Addendum No. 3
Four Rivers Sanitation Authority
Collection Systems Operations Facility
Capital Project No. 2217

This Addendum No. 3, dated February 14, 2023, for the above referenced project, supersedes all contrary and conflicting information in the specifications and contract documents, which are hereby supplemented or revised as follows:

New Collection
Systems Operation
Facility

C101

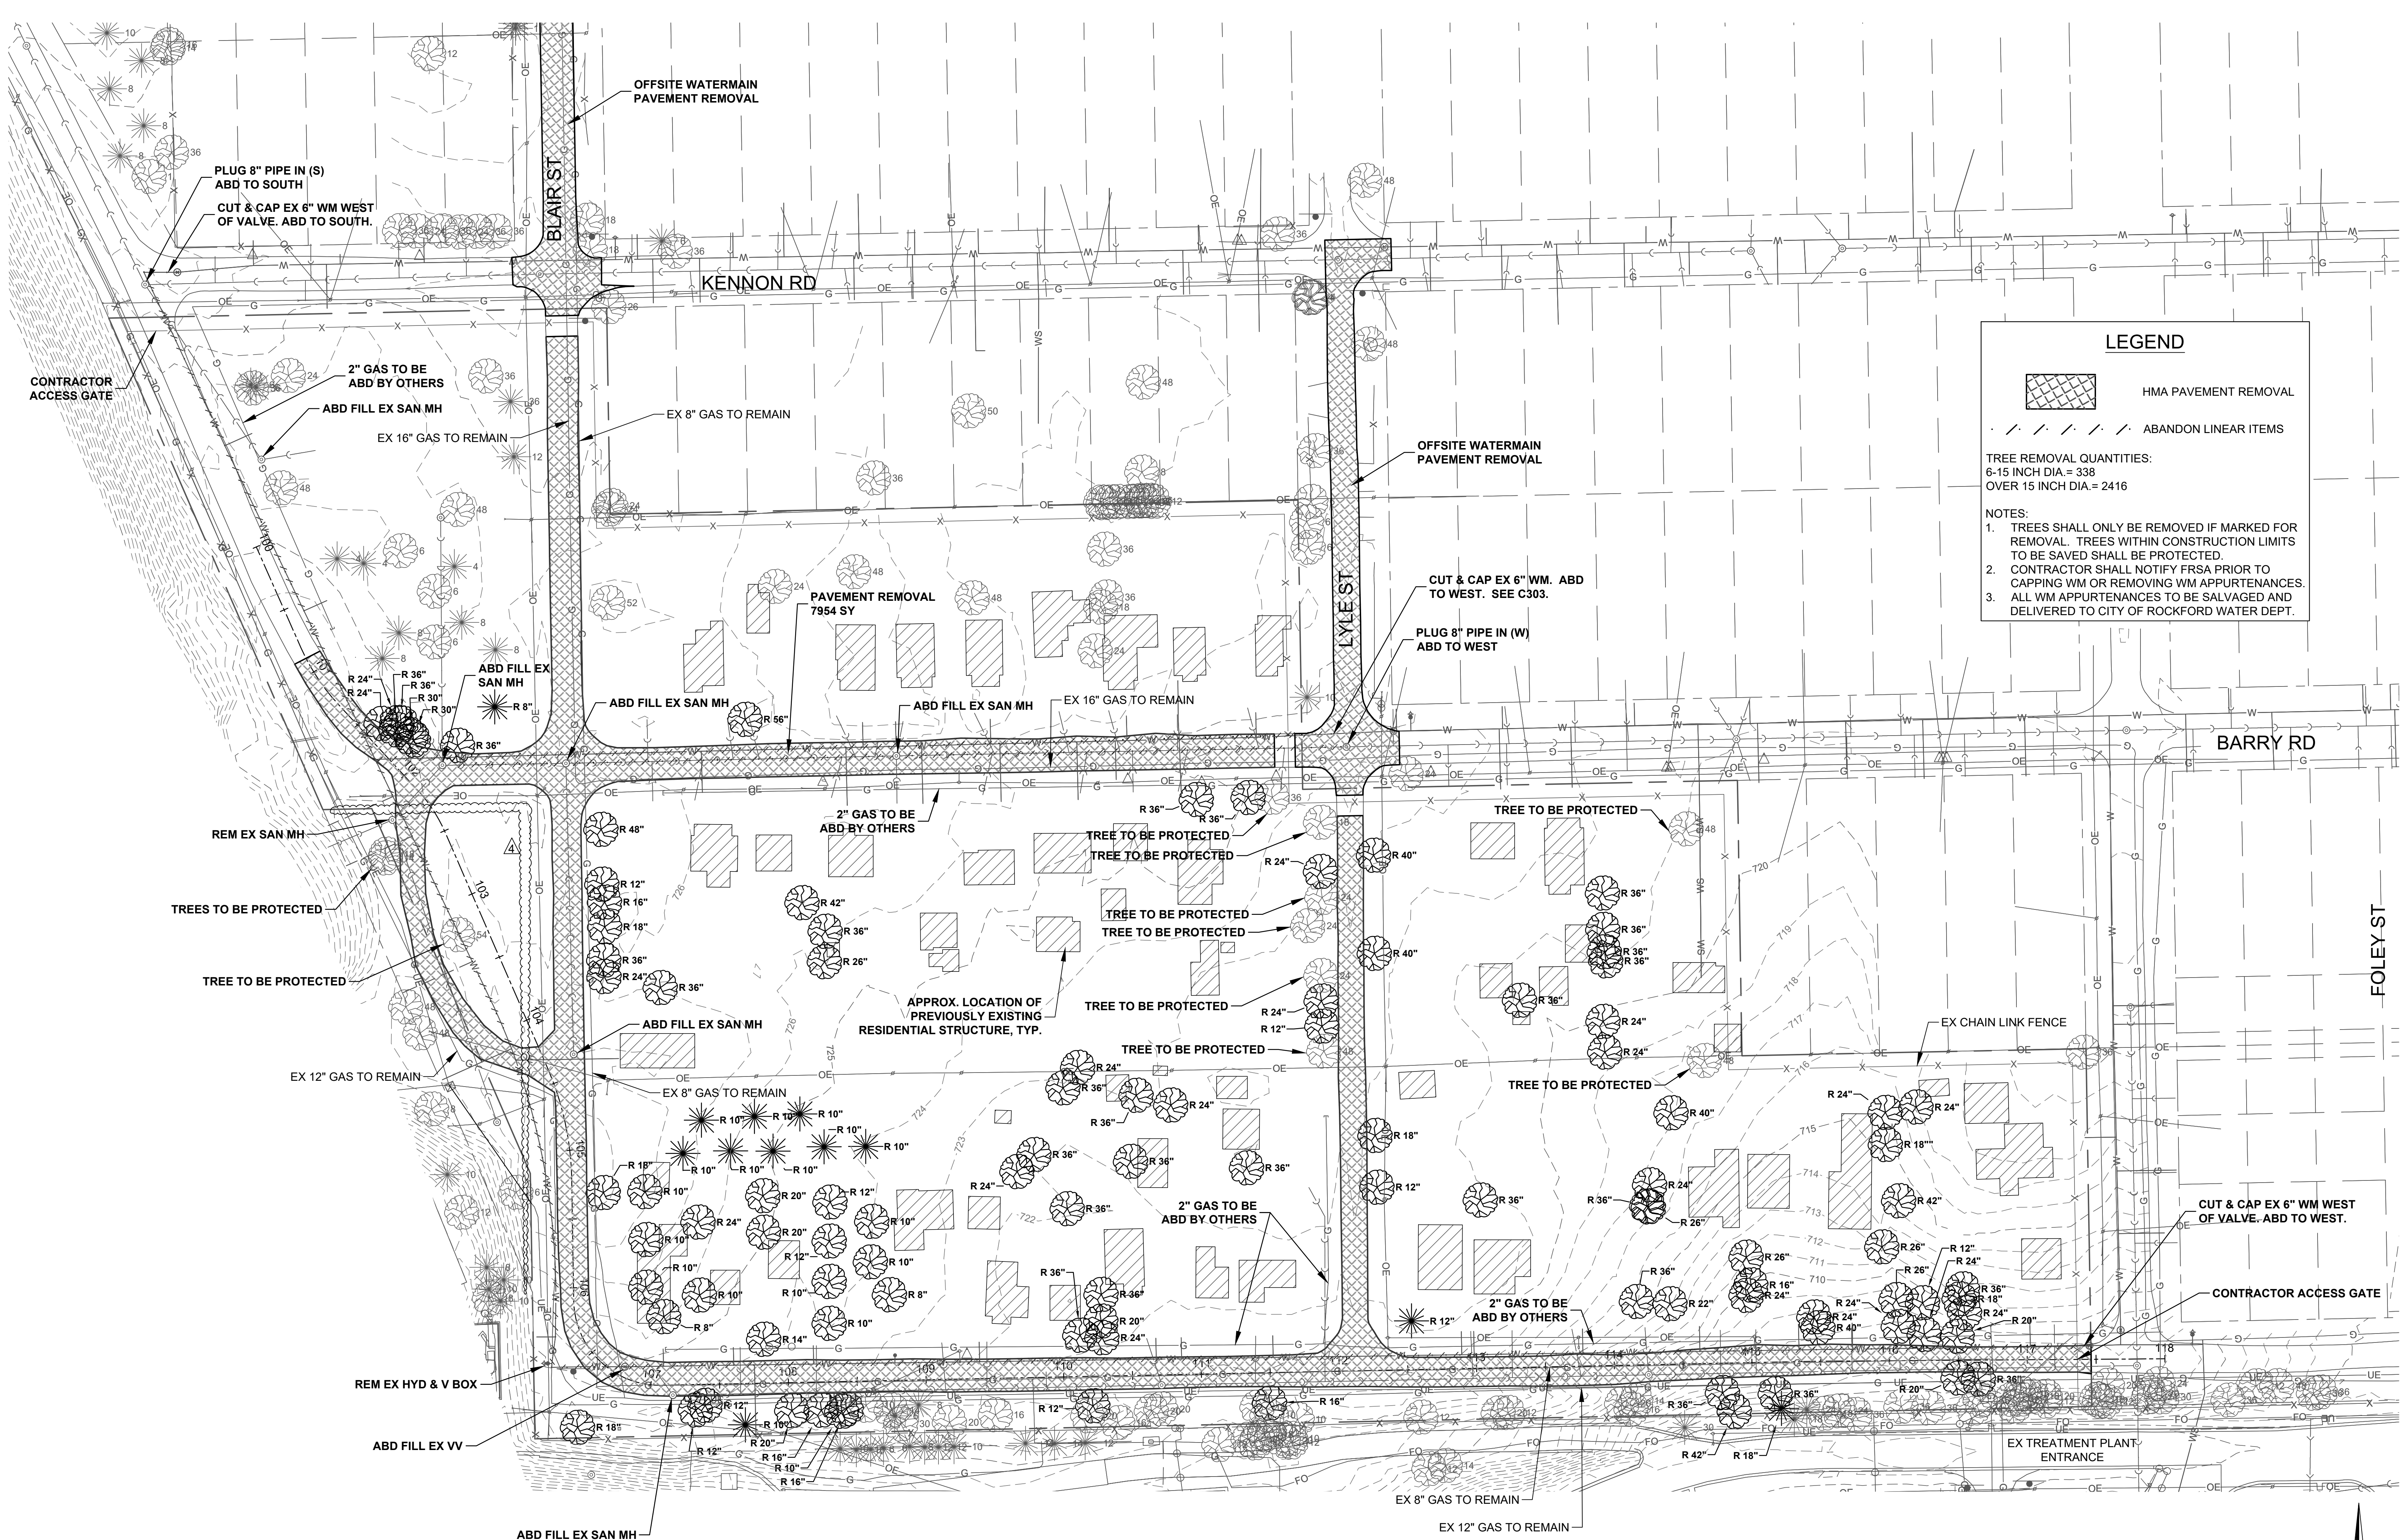
16. Please clarify existing fence removal limits.

21. Please confirm the tree removal quantity noted in the legend on Plan Sheet C101.

24. Where are the existing grades and existing topography survey?

Response: *Reference revised Plan Sheets C101 and C102 for updated limits of fence that was previously removed by FRSA.*

Response: *Reference revised Plan Sheet C101 which shows existing contours.*

NO.	DATE	DESCRIPTION
1.	12/19/22	FOR REVIEW
2.	1/17/23	ISSUED FOR BID
3.	2/13/23	REVISED TO SHOW EX CONTOURS.
4.	2/13/23	REMOVED PORTION OF FENCE FROM ADD. 3 STA 102+ TO STA 106.

C302

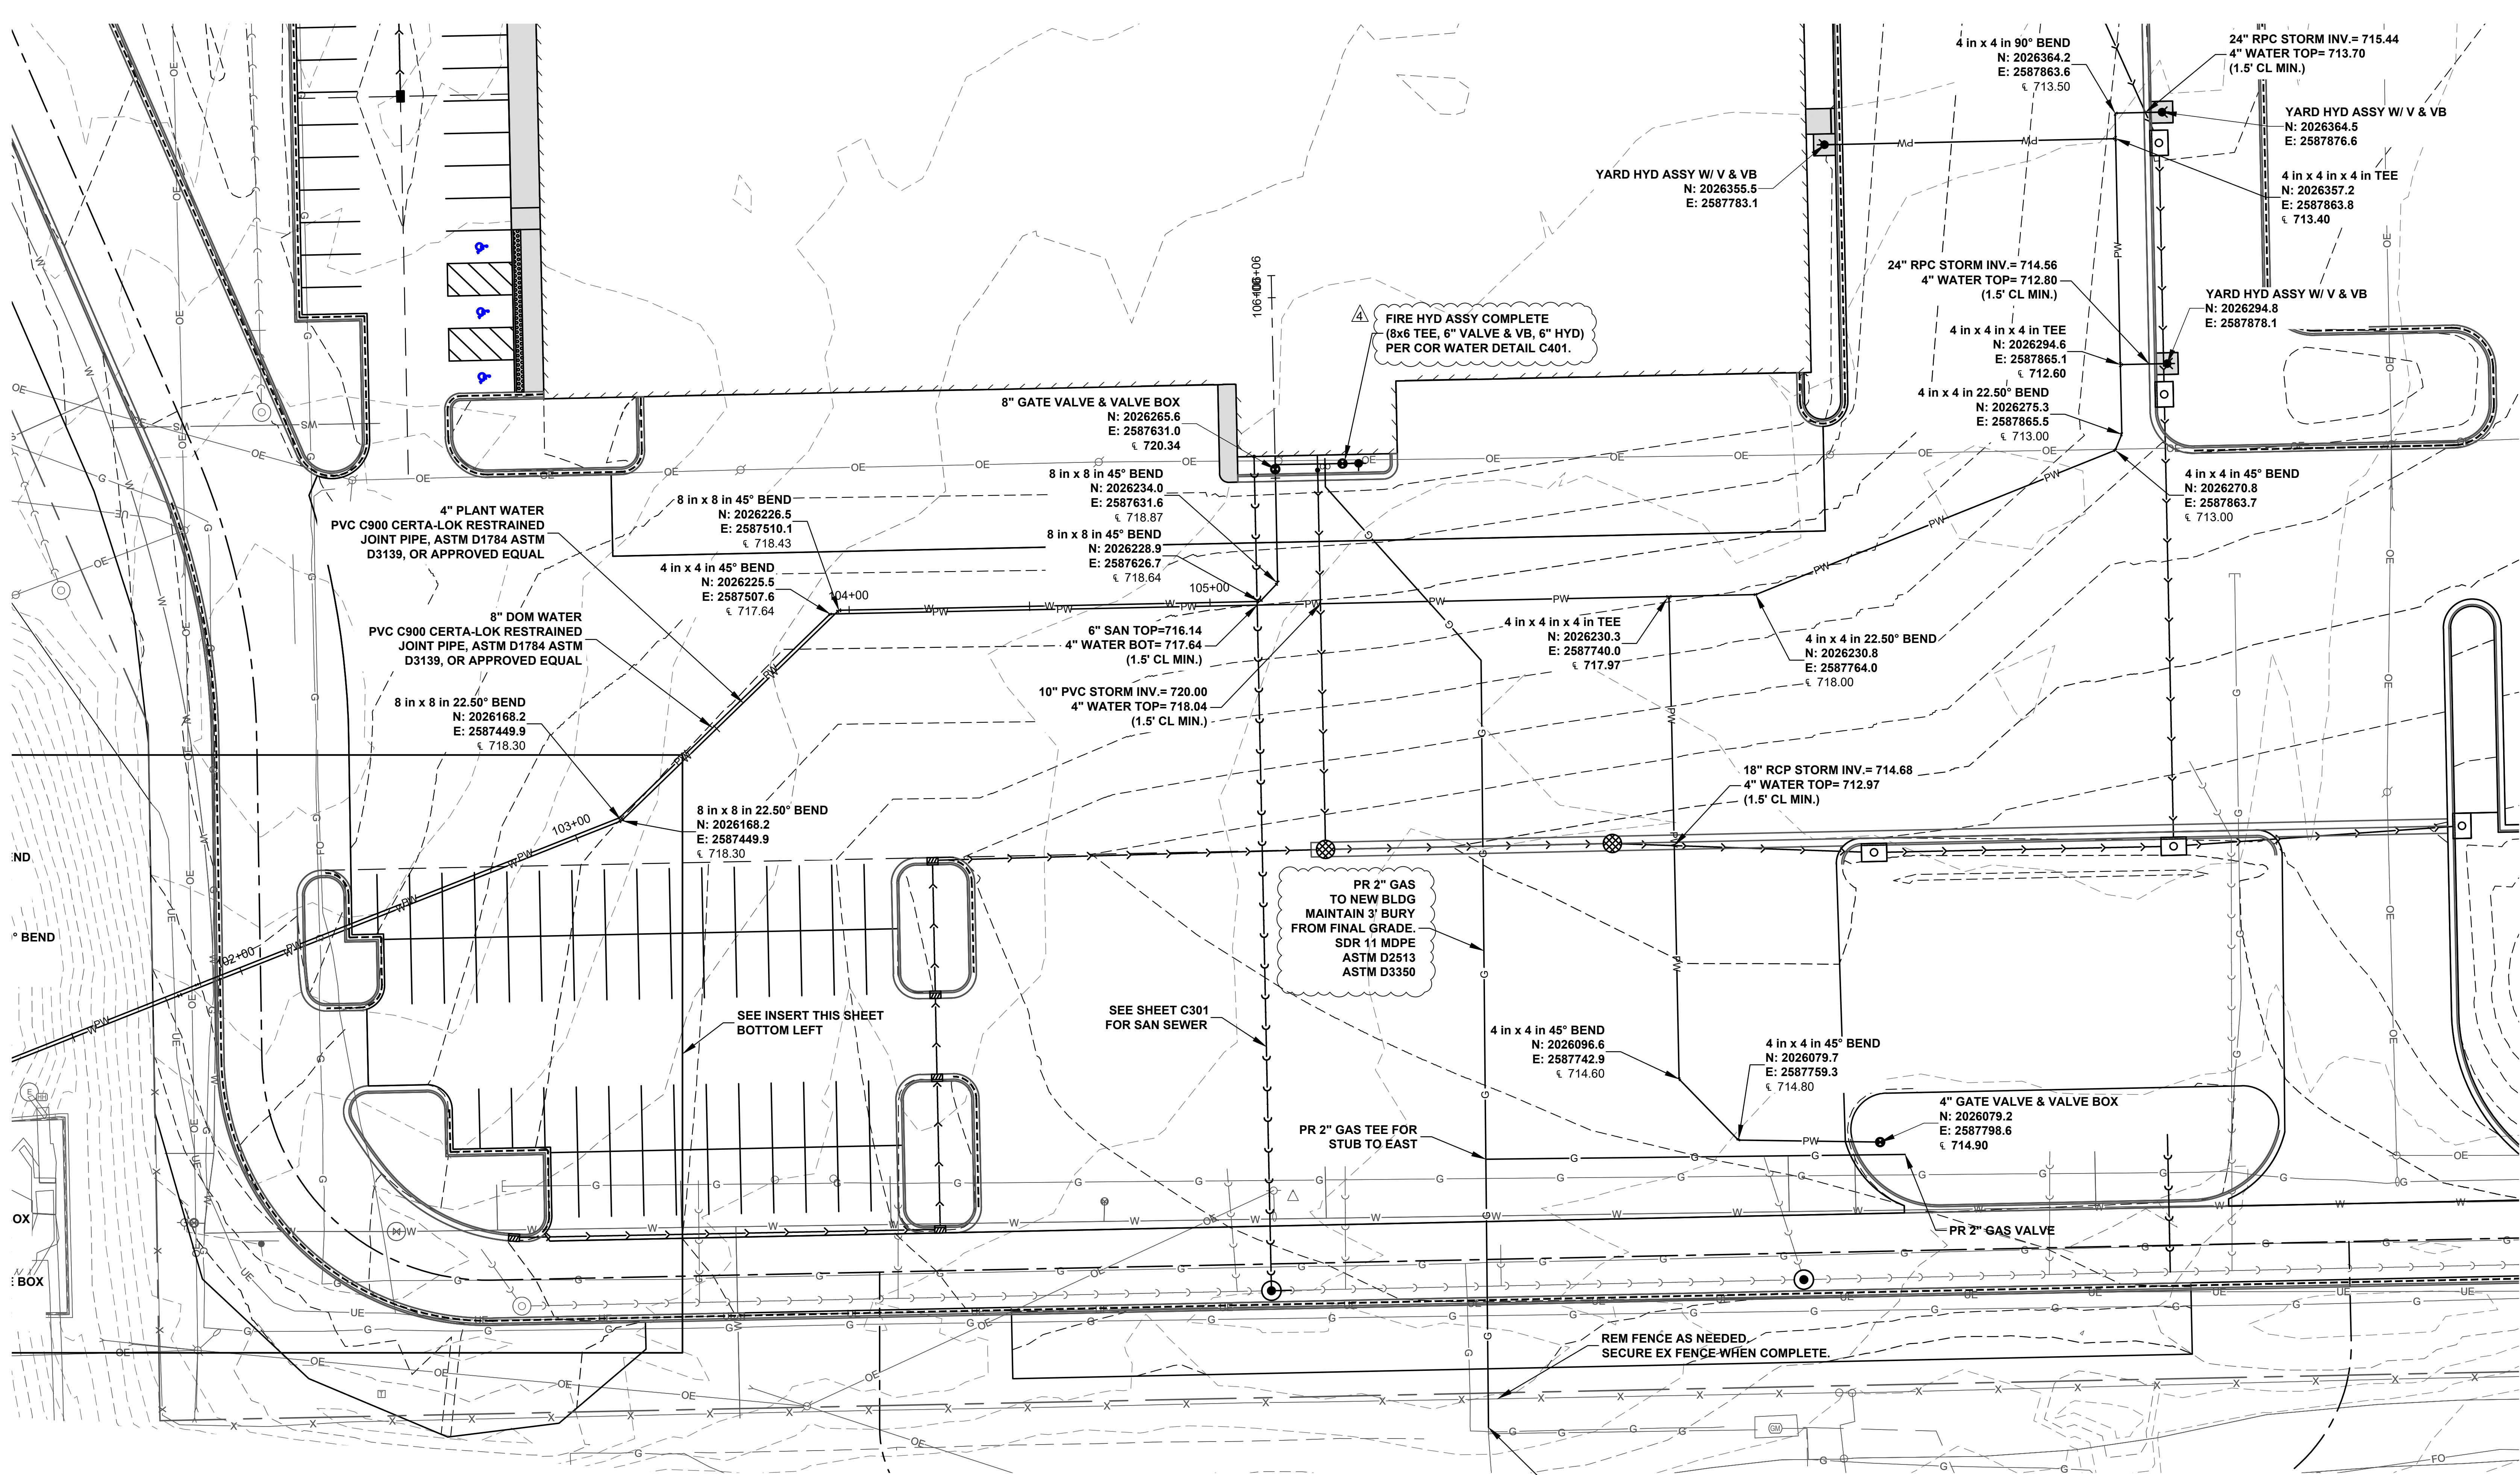
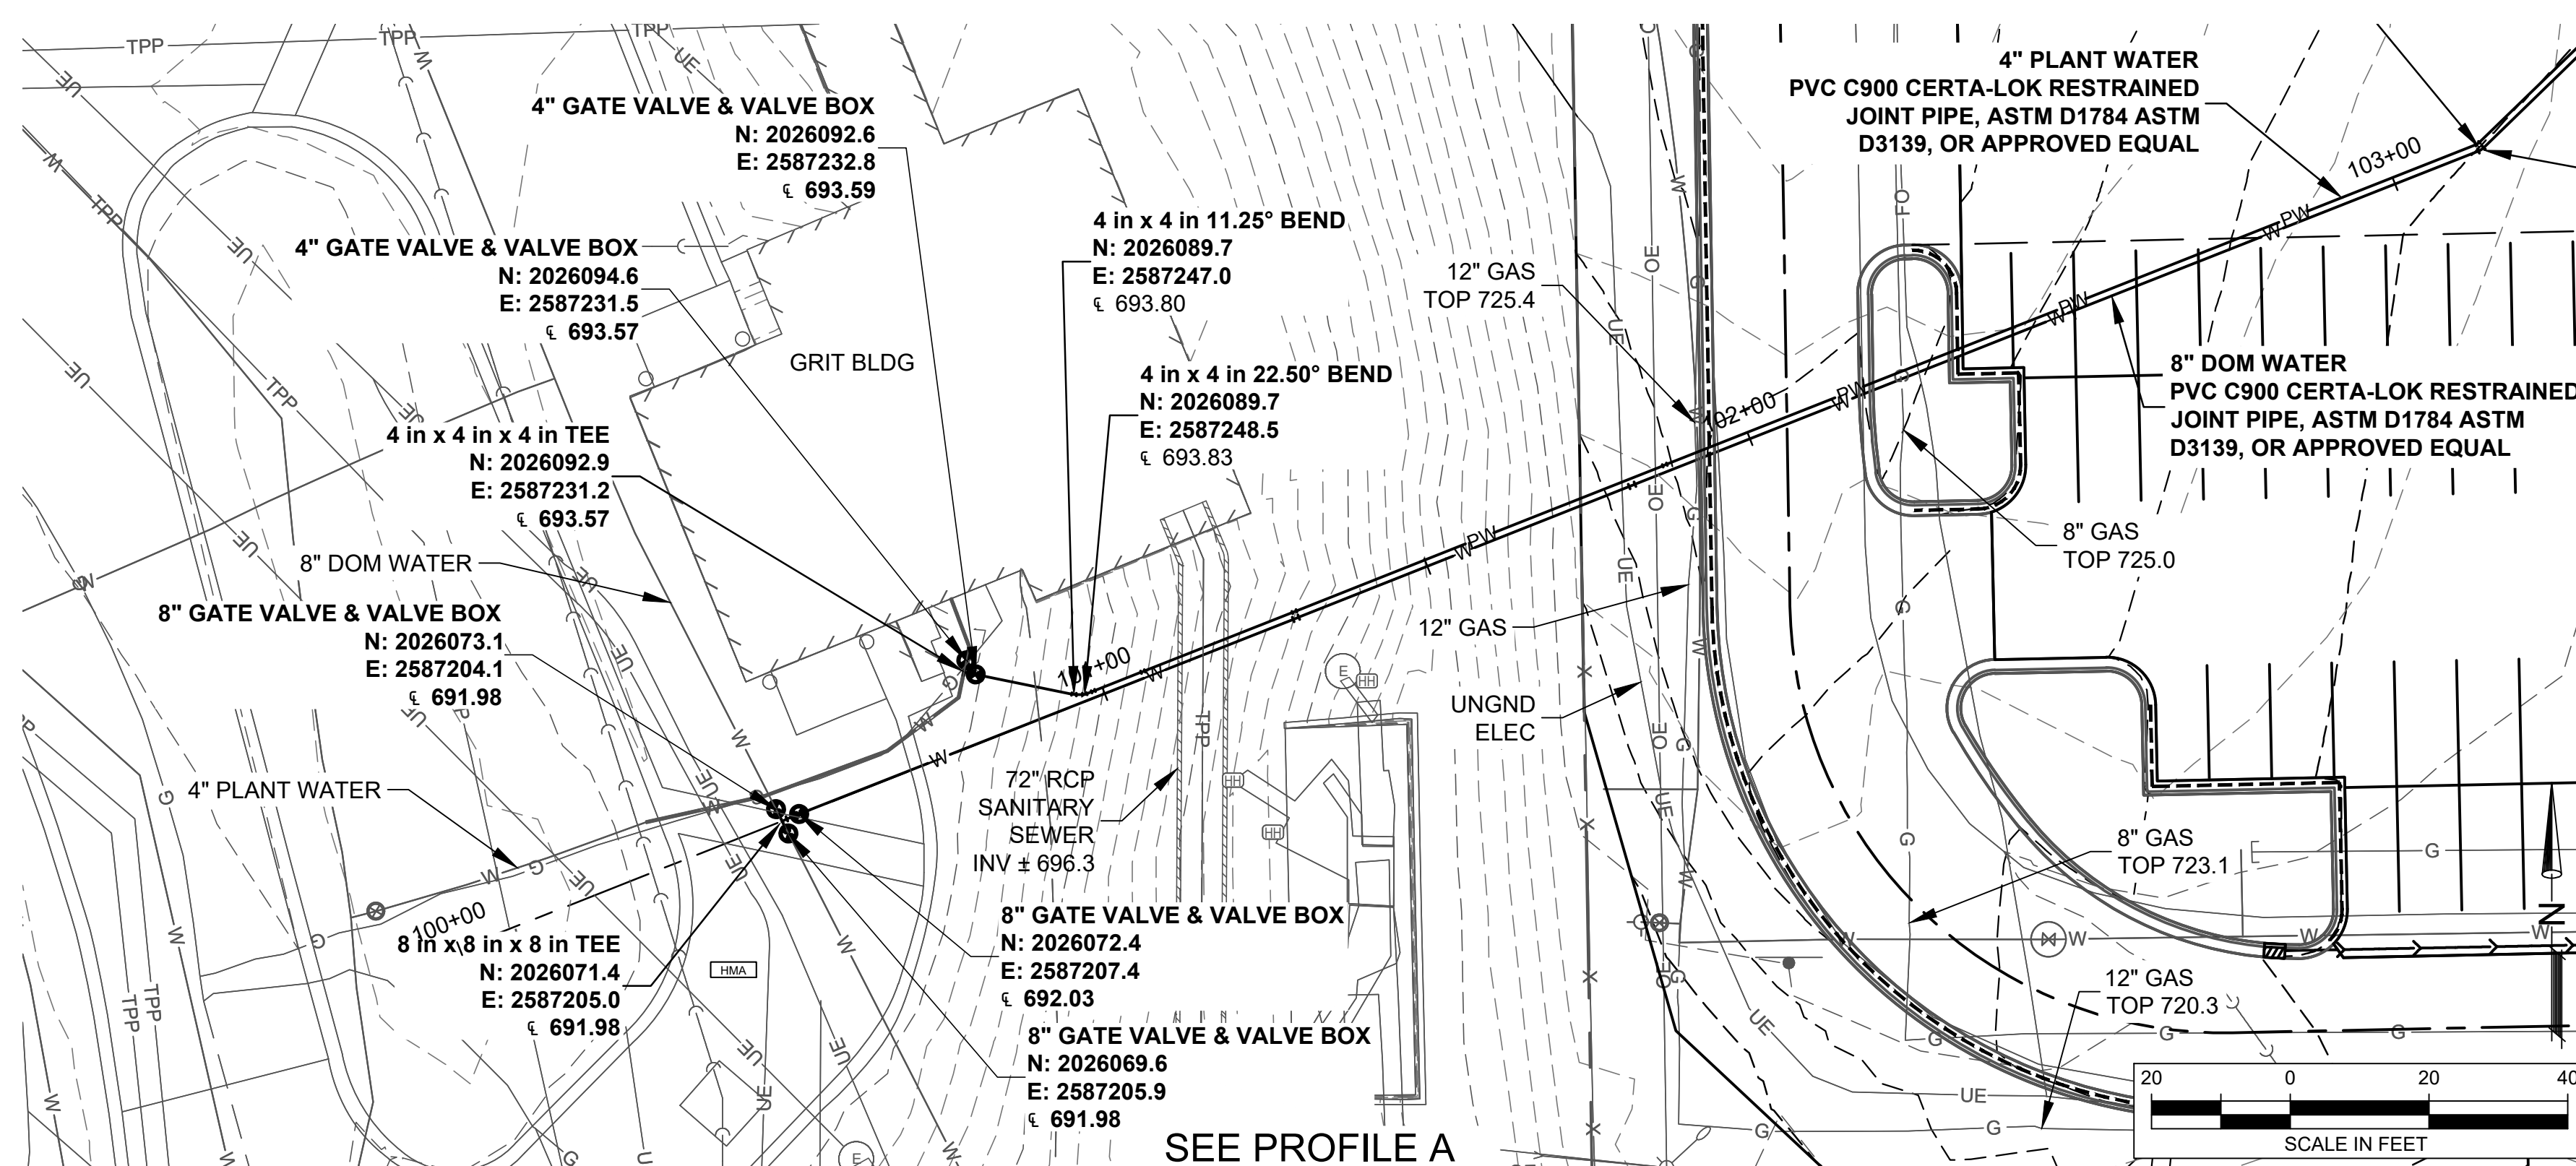
26. What size sleeve is required for the Nicor service? Addendum No. 1 appears to indicate contractor installs the gas service without a sleeve, please confirm. Any meter or valve? Detail? Testing requirements? Note plumbing drawings do not coordinate if gas service is to be by Contractor.

29. Where is the tie-in for the 4" plant water? Near the apparent tie in point there is bold linetype heading towards the building and also heading towards a valve. The new domestic valve connections appear to be shown within pavements. Please clarify scope and clarify the removal extents and desired patching.

33. The note on Plan Sheet C302 indicates the 4" domestic to be directionally drilled, confirm this is a typo and should be 8"?

Response: *No sleeve is required – the Contractor shall connect to the existing 2" PVC gas pipe stub south of the project site as shown on Plan Sheet C302. There is an existing valve south of this connection point so no shutdown is required. This location is on the FRSA-side of the meter so no coordination with Nicor is necessary to make the connection (other than JULIE locates for existing Nicor facilities in proximity of the work). No meter is required. Reference revised Plan Sheet P104 for revised note on gas service.*

Response: *The tie-in for the 4" plant water line is just south of the Grit Building as shown on Plan Sheet C302. The Contractor shall cut out a portion of the existing water line, install a tee, install a valve on the Grit Building side of tee, and install a valve on the new line. FRSA will perform the shutdown. The Contractor shall be responsible for excavating, performing work as shown and described, and backfilling (and compacting) the excavated area. FRSA will restore all pavement and turf within the treatment plant excavated areas for both the domestic and plant water connections.*

Response: *This is a typo; the domestic water is 8" dia.; reference revised Plan Sheet C302.*

NO.	DATE	DESCRIPTION
1.	12/19/22	FOR REVIEW
2.	1/17/23	ISSUED FOR BID
3.	1/24/23 ADD. 2	ADDED MATERIAL SPECIFICATION FOR 2" GAS PIPING.
4.	2/13/23 ADD. 3	ADDED HYD & VALVE ASS'Y AT CORNER NEW BUILDING PER COR COMMENT.
5.	2/13/23 ADD. 3	REVISED NOTES TO CORRECT 8" DOMESTIC WATER.
